SI B61 07 13
General Electrical Systems

Service Action: Repair Corrosion Protection on the Trunk B+ Connector

F30

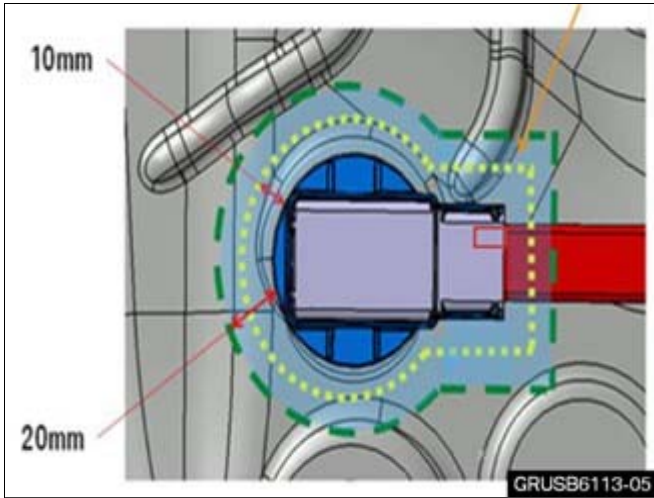
The corrosion protection on the outside of the trunk (back of rear right-hand wheel arch) around the battery positive connector is insufficient, and leads to corrosion on the body.

Coat the area around the positive battery cable connection with underbody protection (cavity protection spray).

<ol style="list-style-type: none"> 2. Ensure the area around the connector is clean and dry in the
--	---

marked area, as shown in the illustration.

3. Apply the underbody corrosion protection (cavity protection spray) over and around the connector, as shown. The connector should be completely sealed.
4. Reinstall the partially removed wheel arch cover.
